# Accessibility Review

## Assessment report

The proposal comprises the construction of the new Chau Chak Wing Museum in the north eastern sector of the Camperdown campus. The proposed museum will comprise a new five level building (maximum of three storeys above ground) with central void and will include:

Project Title  
**UNIVERSITY OF SYDNEY**  
**CHAU CHAK WING MUSEUM**

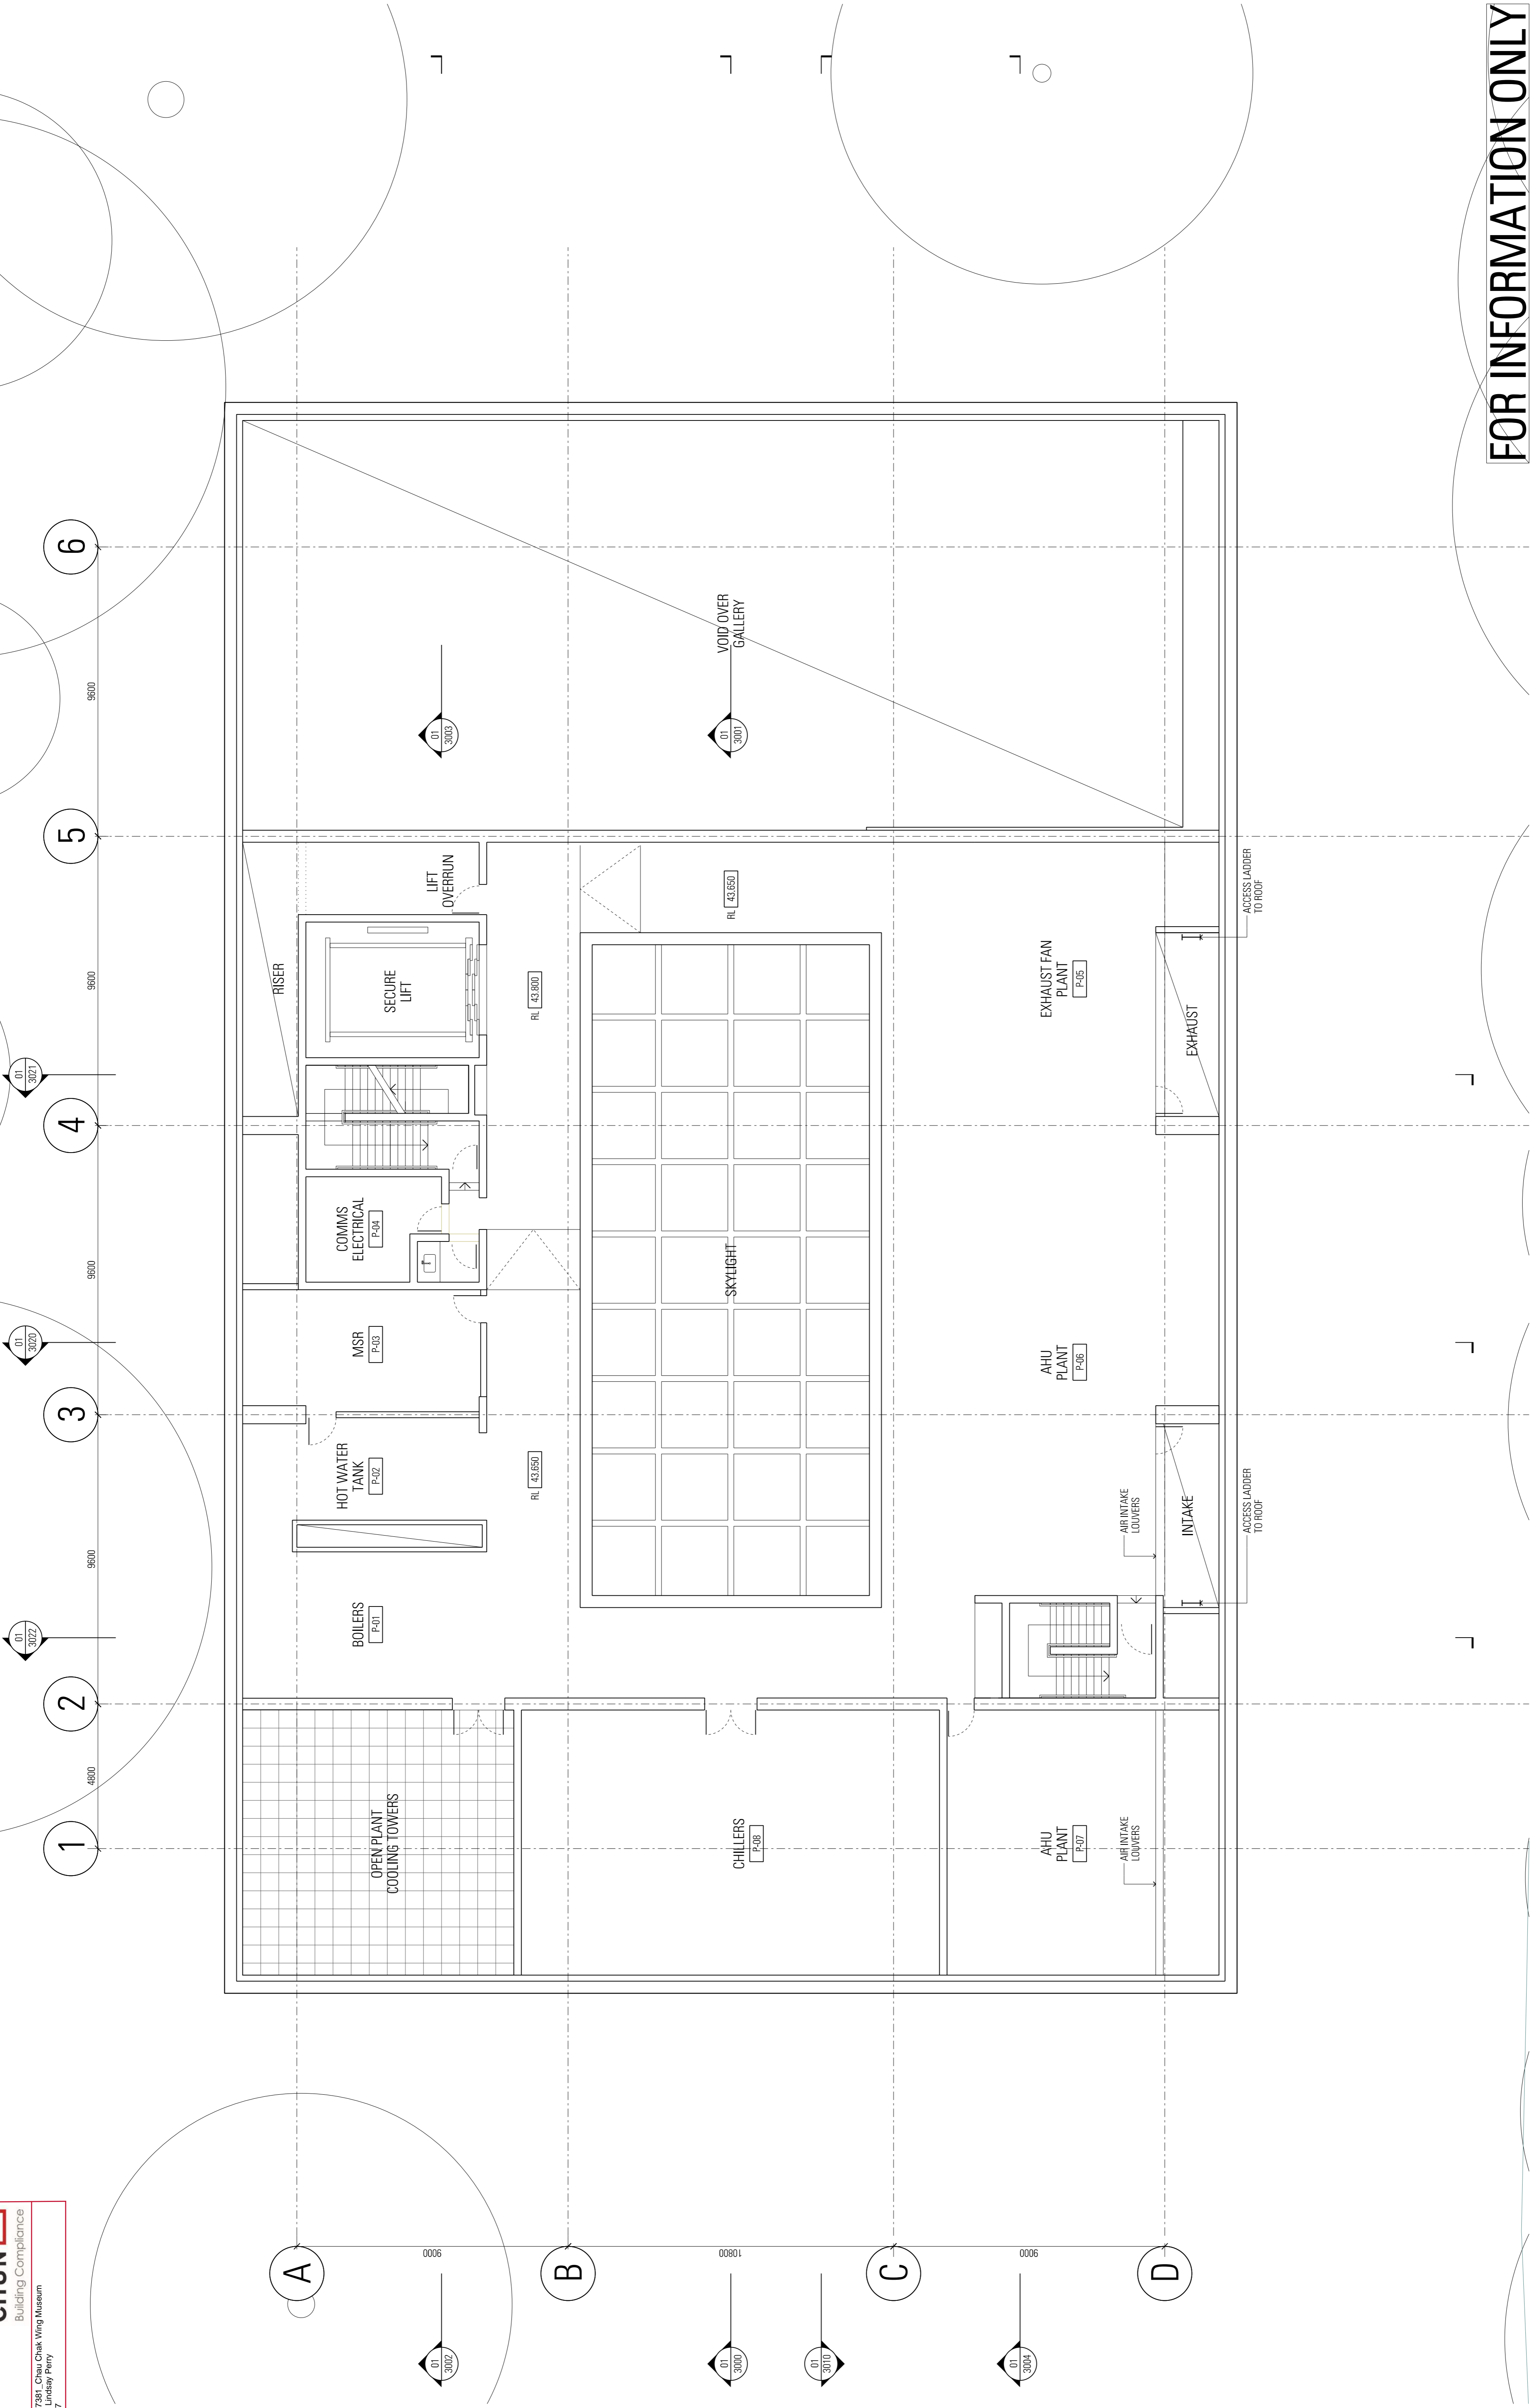
Generally, contrasting wall and floor surfaces should be provided. At a minimum skirting boards which provide suitable contrast to the floor surface assist people with low vision in identifying perimeters of corridors and accessible spaces.

All doorways shall have a minimum luminance contrast of 30% between the door leaf / frame and the adjacent wall, for a minimum width of 50mm (AS1428.1 (2009), Clause 13.1).
